Title: Cavalon (Rotorhead III) & MTO2017 Pitch Trim Pressure Correction		
AG-SB-2019-02-B-EN		Compliance Category:
Applicability		A – MANDATORY B – RECOMMENDED C – OPTIONAL
Aircraft type & model: Cavalon & MTO2017 with Rotorhead III	Affected Serial number(s): All Cavalon from V00349 & all MTO2017 (Rotorhead III)	
The maintenance manual to be referenced is this stated or subsequent issue.		As per AutoGyro website
This form is the response from AutoGyro GmbH either against a problem found in the product in service requiring a containment or rectification action, or as service information for aircraft modification incorporation. For help, contact AutoGyro on 49(0)5121 88056-00, or email airworthiness@auto-gyro.com.

Reason and overview of the Service Bulletin (cause of problem if known)

(Pic.1)

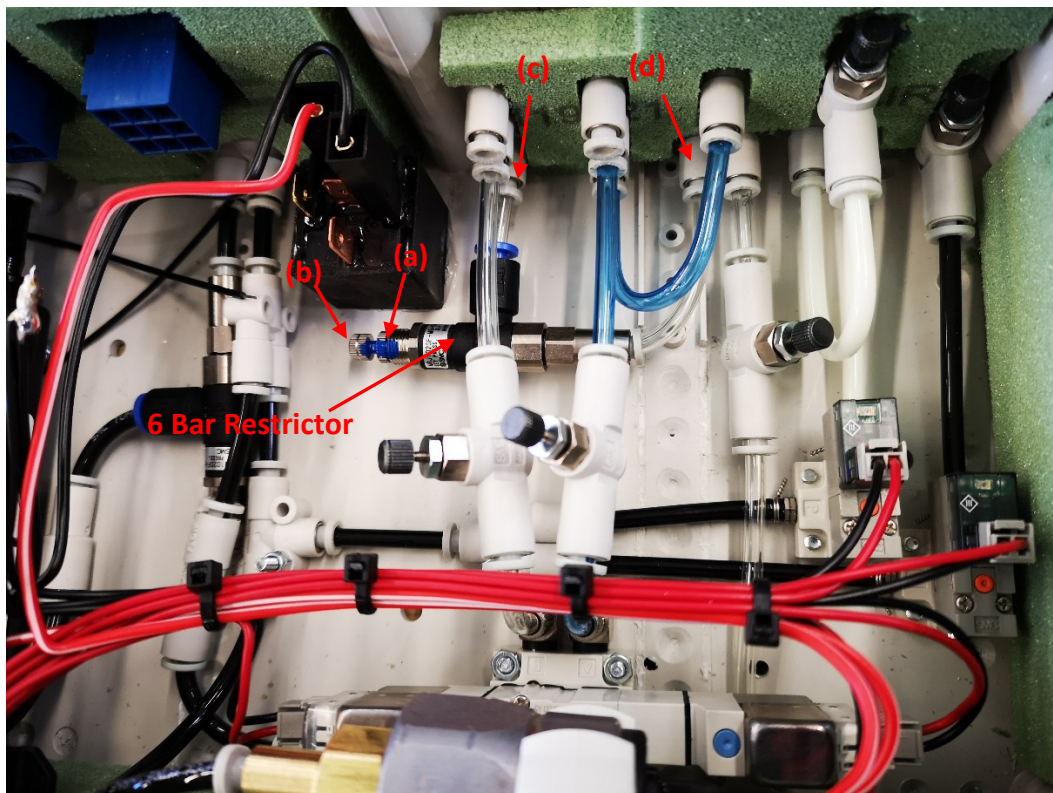
1. Remove the upper pneumatic connection (clear hose) of the brake/trim cylinder and attach a manometer with a non-return valve (Pic.1)
2. Unhook the rotor bag from the nose and ensure the rotor is able to pitch rearwards under control (a second person holding the bag chord).
3. Switch the flight/brake switch to flight, ensure the propeller is clear of obstruction and turn on the ignition.
4. Apply nose up trim by moving the 4-way switch on the top of the stick to the rear.
5. Note the maximum pressure reading on the manometer. If it is 8 bar then no further action is required. Reconnect the upper brake/trim cylinder pneumatic hose and mark with mechanic paint.
6. If the pressure is more than 0.25 bar less than that displayed in the cockpit then carry out steps 7-13:

(Pic.2)

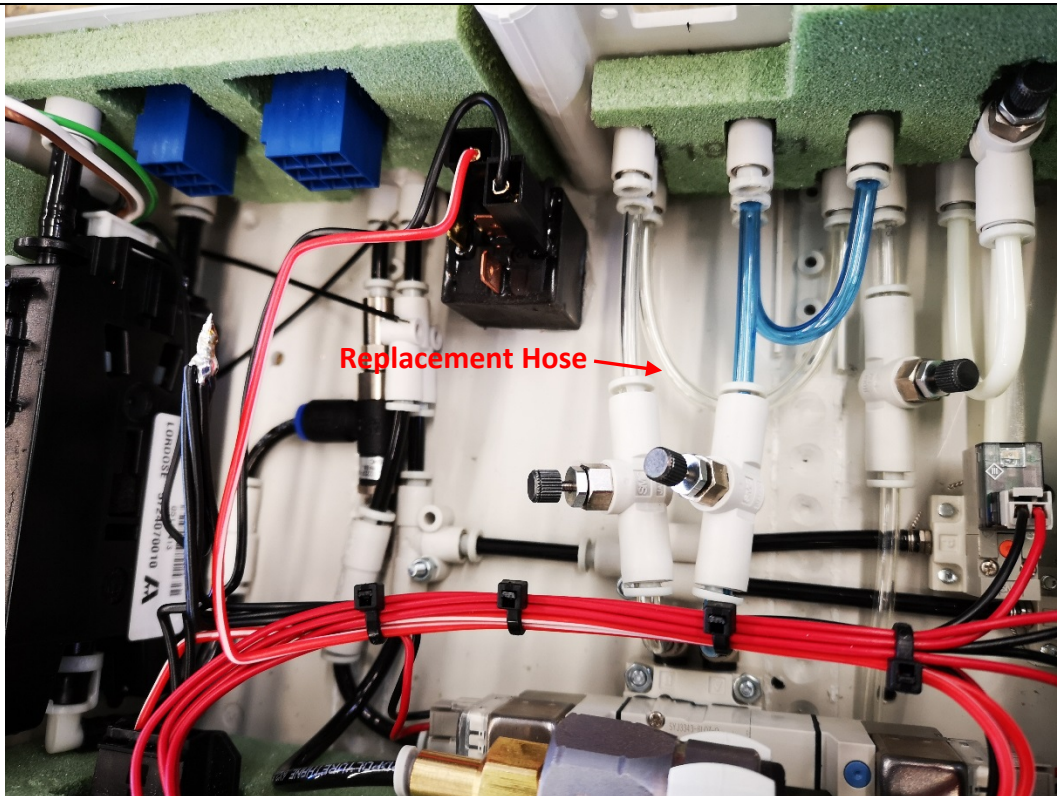
7. Gain access to the 6 bar pressure restrictor (pic.2) by removing the cover of the pneumatic box (in the nose area behind the cockpit of the Cavalon 915, behind the engine bay firewall in the Cavalon 914, or in the nose compartment of the MTO2017 – 6 screws).
WARNING: If the box has the heating option fitted then the elements are attached to the lid and must be disconnected from the box at the black 3 pin connector.

8. **Either:** release the lock-nut of the adjustment knob of the restrictor (a) and screw the adjustment knob (b) in until 8 bar is measured in steps 1-5 above. Re-lock the lock-nut and mark with mechanic paint.

9. **Or the preferred solution:** remove the restrictor and connecting hoses at points (c) and (d) (pic.2) and replace with a single piece of clear pneumatic hose of approx. 130mm length (pic.3).
